Re: BZA Appeal No 17109. 2nd Remand of Kalorama Citizens Association

THIS SET OF DRAWINGS (PAGES A1-A16) AMENDS AND REVISES THE WORK AT 1819 BELMONT RD., N.W. WHICH IS BEING PERFORMED UNDER THE FOLLOWING GENERAL BUILDING PERMIT NUMBERS:

1819 BELMONT RD., N.W. WASHINGTON, DC 20009	REVISIONS/ADDENDA TO PERMIT(S) AS NOTED 11/10/03
NORMAN SMITH ARCHITECTURE 202.462.5886

LWR LEVEL FLR PLAN

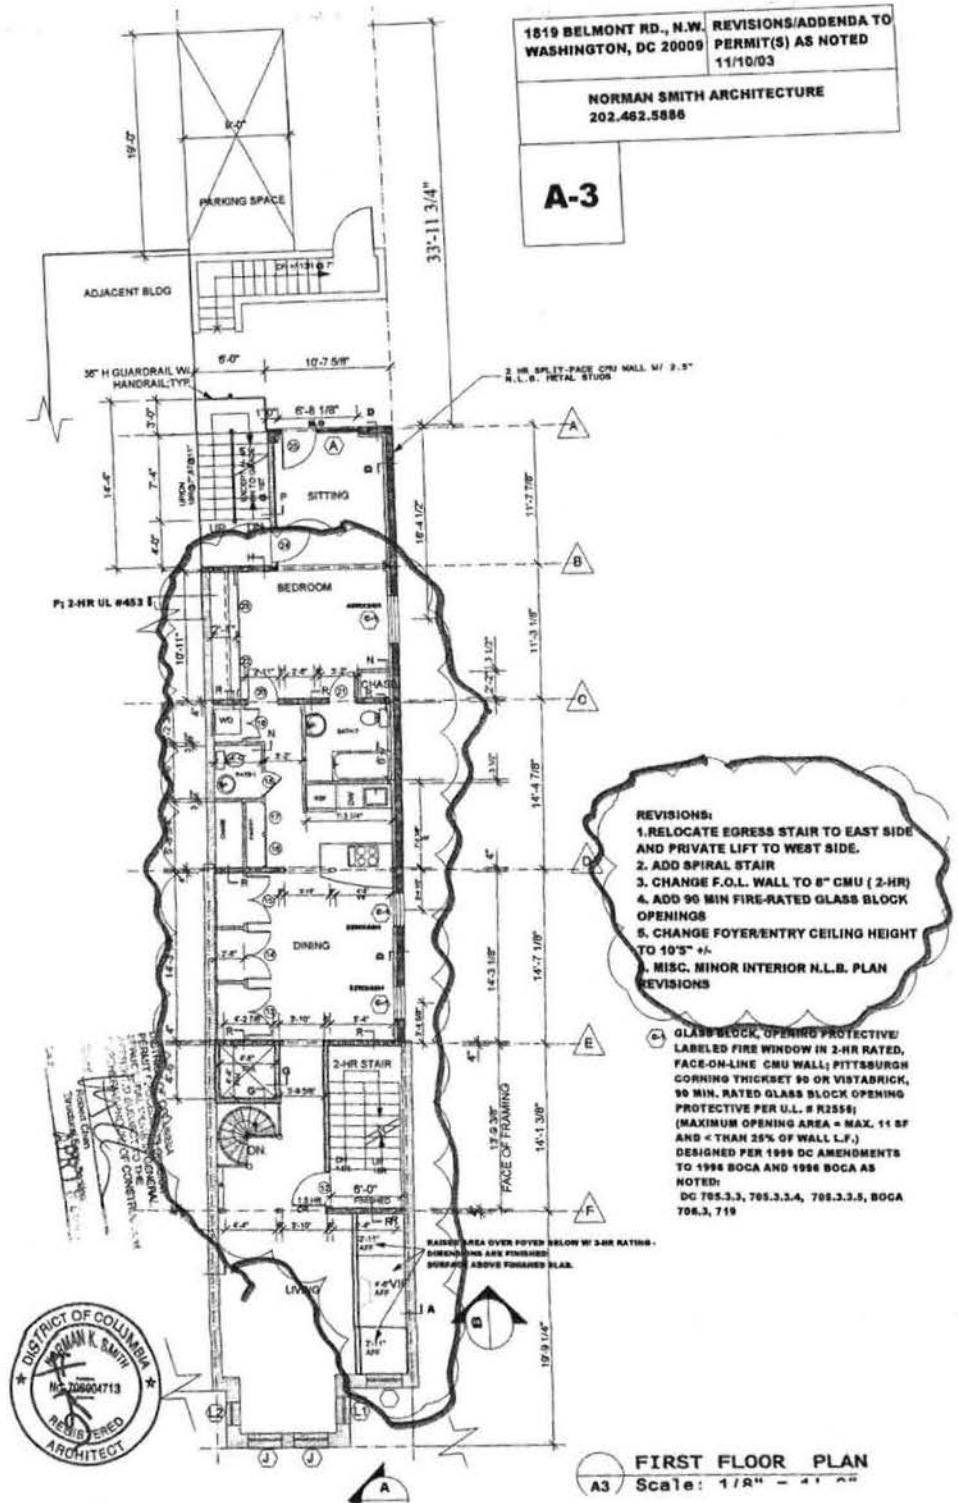
1. RELOCATE EGRESS STAIR TO EAST SIDE AND PRIVATE LIFT TO WEST SIDE.
2. ADD BATHROOM AND SPIRAL STAIR AT LOWER LEVEL
3. REVISE PRIVATE LIFT MOTOR LOCATION

FIRST FLOOR PLAN
Scale: 1/8" = 1'-0"

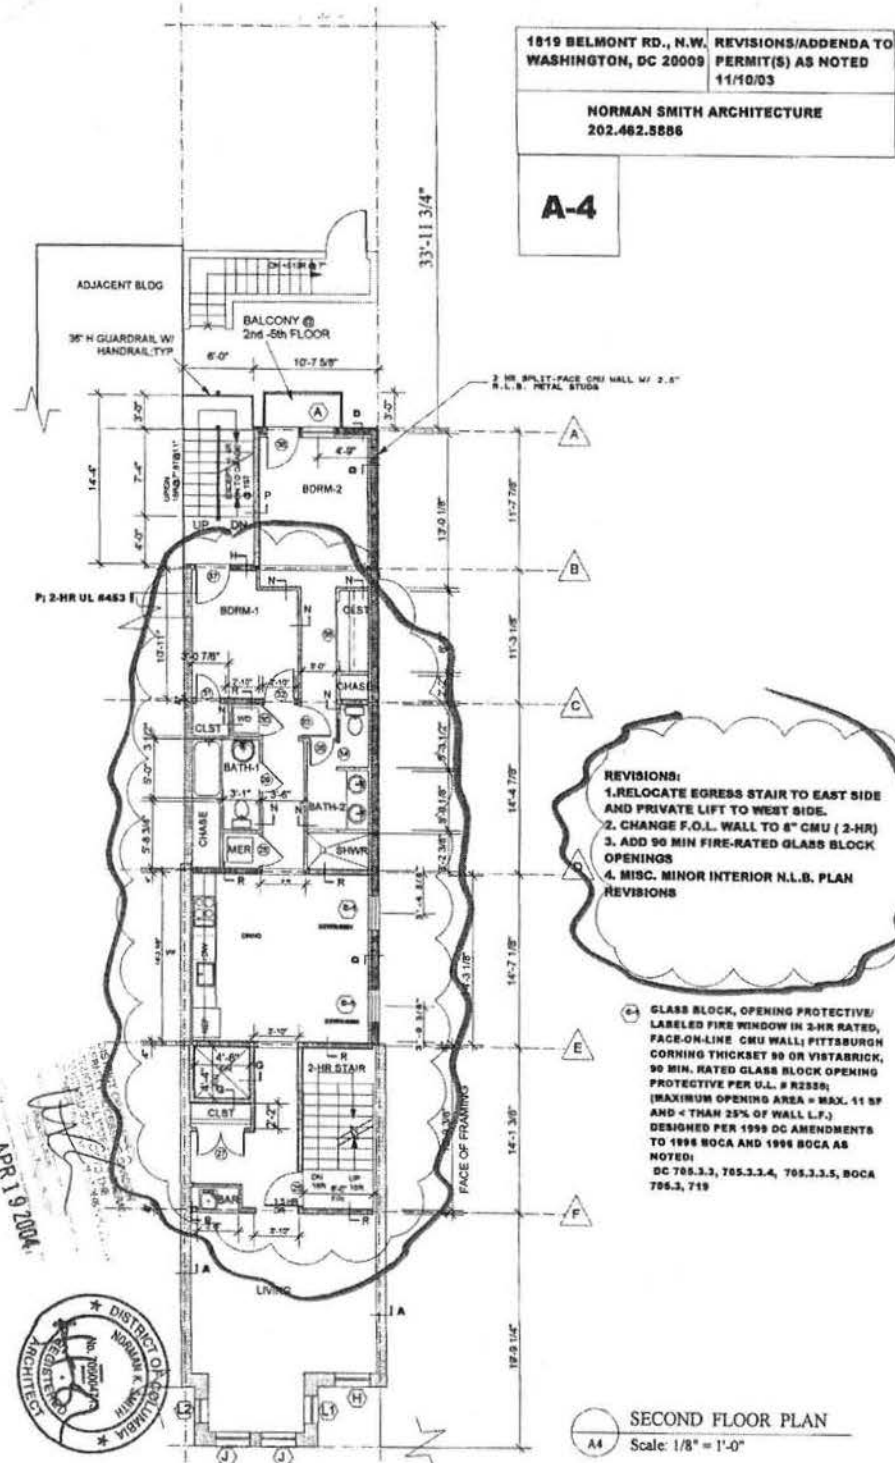
1. RELOCATE EGRESS STAIR TO EAST SIDE AND PRIVATE LIFT TO WEST SIDE.
2. ADD SPIRAL STAIR
3. CHANGE F.O.L. WALL TO 8" CMU (2-HR)
4. ADD 90 MIN FIRE-RATED GLASS BLOCK OPENINGS
5. CHANGE FOYER/ENTRY CEILING HEIGHT TO 10'3" +/-
6. MISC. MINOR INTERIOR N.L.B. PLAN REVISIONS

GLASS BLOCK, OPENING PROTECTIVE/
LABELED FIRE WINDOW IN 2-HR RATED/
FACE-ON-LINE CMU WALL; PITTSBURGH
CORNING THICKEST 96 OR VISTABURGH
90 MIN. RATED GLASS BLOCK OPENING
PROTECTIVE PER U.L. # R2566;
(MAXIMUM OPENING AREA = MAX. 11 SF
AND < THAN 25% OF WALL L.F.)
DESIGNED PER 1999 DC AMENDMENTS
TO 1996 BOCA AND 1996 BOCA AS
NOTED:
DC 705.3.3, 705.3.3.4, 705.3.3.5, BOCA
706.3, 719

ATTIC PLAN

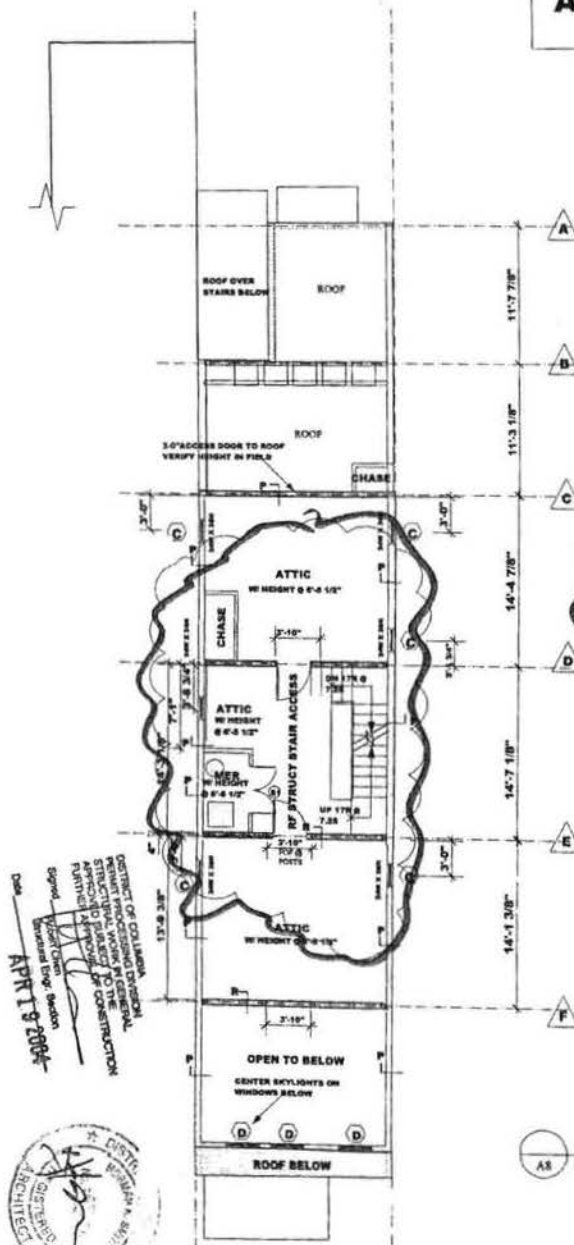
1. ADD 90 MINUTE FIRE RATED OPENING PROTECTIVE FIRE WINDOW
2. RELOCATE MER TO ATTIC; NO CHANGE IN FAR
3. MISC. MINOR INTERIOR N.L.B. PLAN REVISIONS
4. CHANGE EXTERIOR N.L.B. WALL FROM 2-HR UL# U-424 TO 2-HR UL# U-453 (WALL TYPE F)

1" TECHNICAL GLASS PRODUCTS IQU IN MANUFACTURER'S RATED STEEL FRAME AS 90 MINUTE FIRE RATED OPENING PROTECTIVE FIRE WINDOW IN 2 HOUR RATED FACE-ON-LINE N.L.B. STEEL STUD WALL.
DESIGNED PER 1996 DC AMENDMENTS TO 1996 BOCA AND 1996 SOCA AS NOTED;
DC 705.3.3, 705.3.3.4, 705.3.3.5, BOCA 706.3, 719

WEST ELEVATION

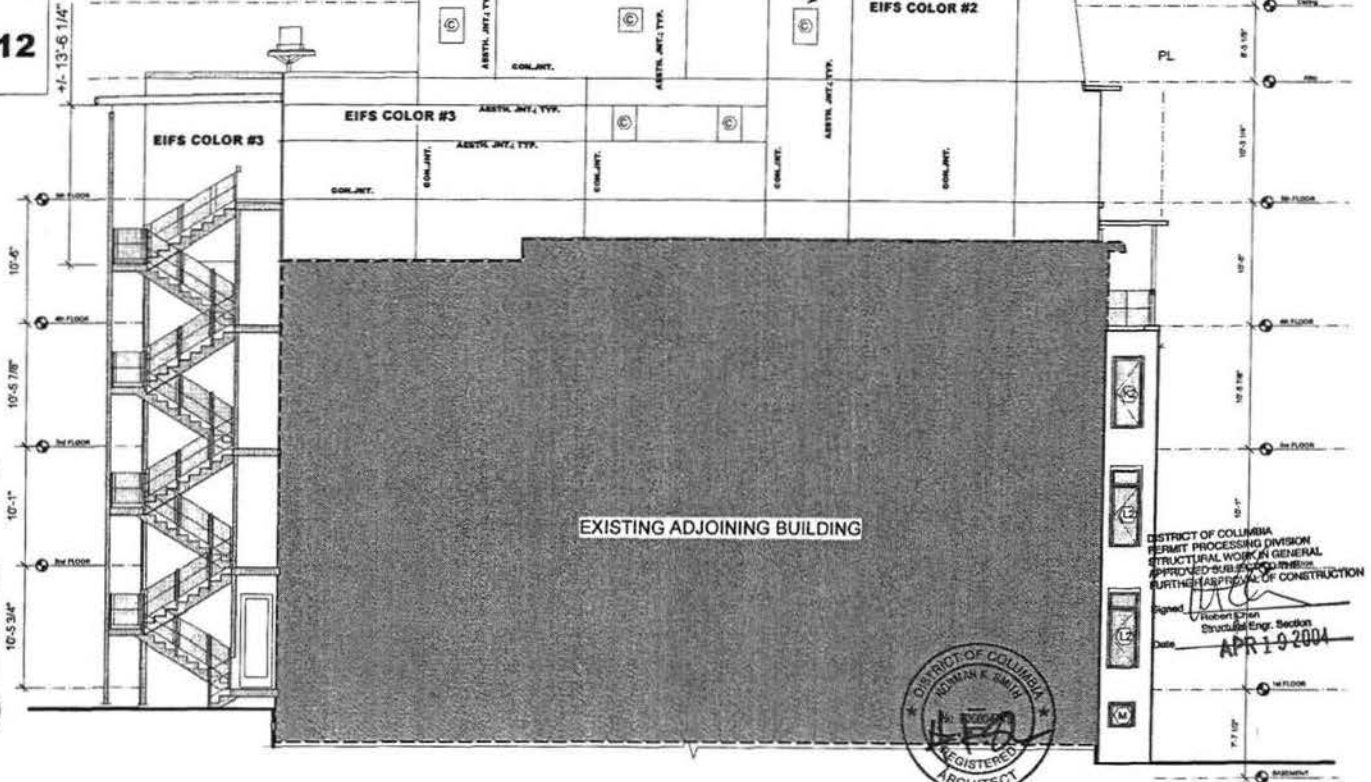
PART OF ROOF STRUCTURE
REVISED AND REMOVED
UNDER PREVIOUS PERMIT

1" TECHNICAL GLASS PRODUCTS IGU IN MANUFACTURER'S
RATED STEEL FRAME AS 90 MINUTE FIRE RATED OPENING
PROTECTIVE FIRE WINDOW IN 2 HOUR RATED FACE-ON-LINE
N.L.B. STEEL STUD WALL. TYPICAL OF 5 UNITS THIS
ELEVATION
